GRANDE OAKS AT HILLCREST SUBDIVISION

APPLICATION NUMBER 4 DATE February 1, 2007

DETAIL SITE PLAN

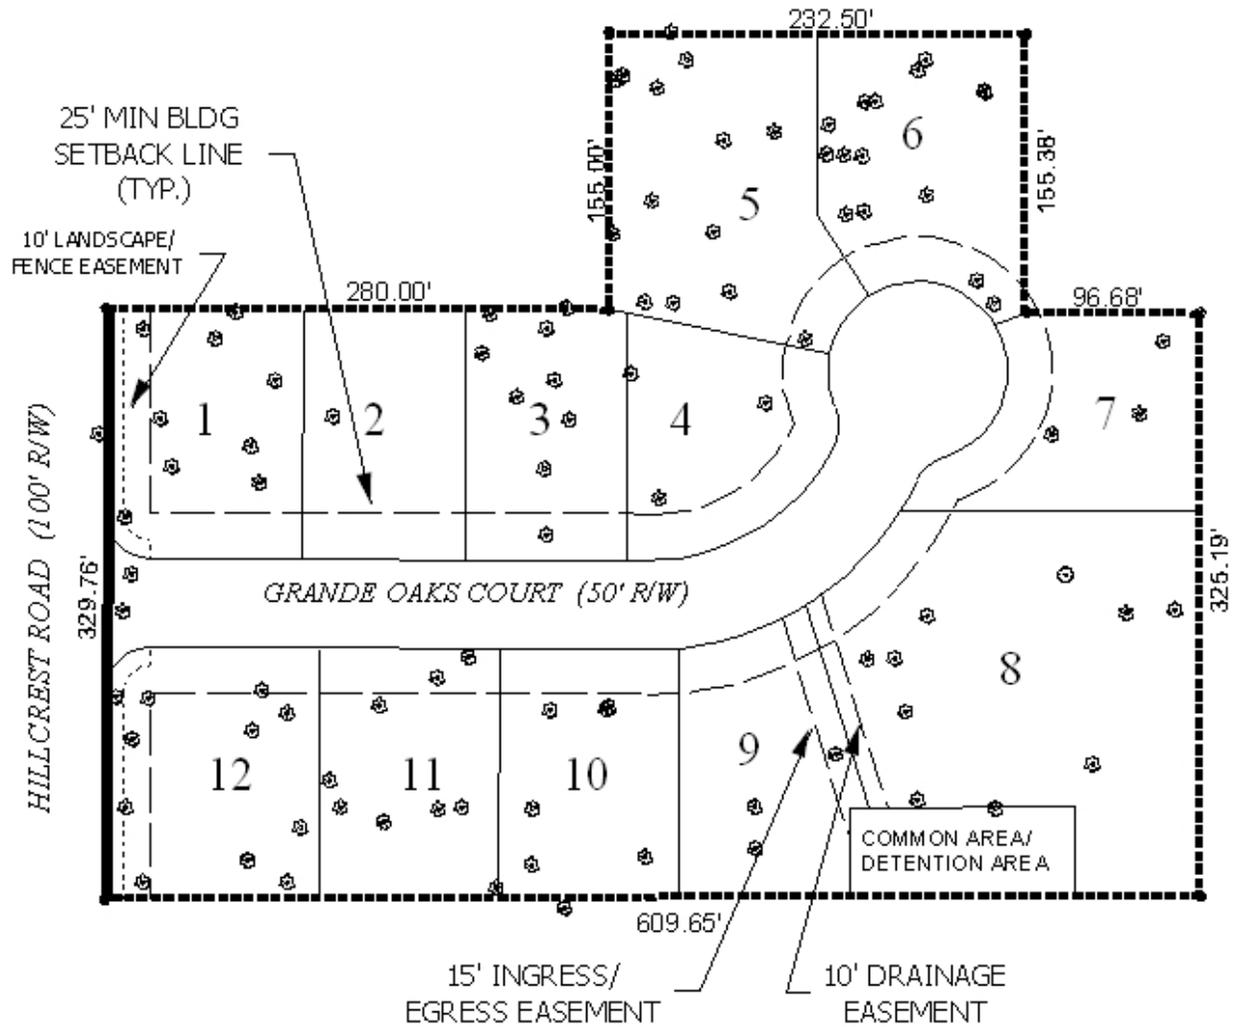
The plat illustrates the proposed 5.4 ± acre, 12-lot subdivision which is located on the side of Hillcrest Road, at the East terminus of Angela Court and is in Council District 6. The applicant states that the site is served by public water and sanitary sewer. The purpose of the application is to create 12 lots from two metes and bounds parcels. The site fronts Hillcrest Road, a planned major street with an adequate 100-foot right-of-way.

The site involves the creation of new streets, which must be constructed to City Engineering standards. Because the site adjoins a one-acre landlocked parcel to the Southeast, a street-stub constructed to City Engineering standards should be provided, or the land-locked parcel should be included in the subdivision, and a minimum of 25-feet of frontage provided on the cul-de-sac proposed for the development. For access management, lots with frontage on Hillcrest Road should be denied direct access to Hillcrest Road.

The plat shows a common area detention area is shown near the Southeast corner of the site, with access provided through a drainage and access easement. A note should be placed on the final plat stating that maintenance of the common (and/or detention) area is the property owners' responsibility.

Based on the preceding, this application is recommended for Holdover until the March 1st meeting, with revisions due by February 5th, to allow the applicant to undertake the following: 1) revision of the application and plat to include and provide access to the land-locked parcel to the South (with additional labels and postage); or 2) revision of the plat to provide a street-stub to the land-locked parcel to the South.
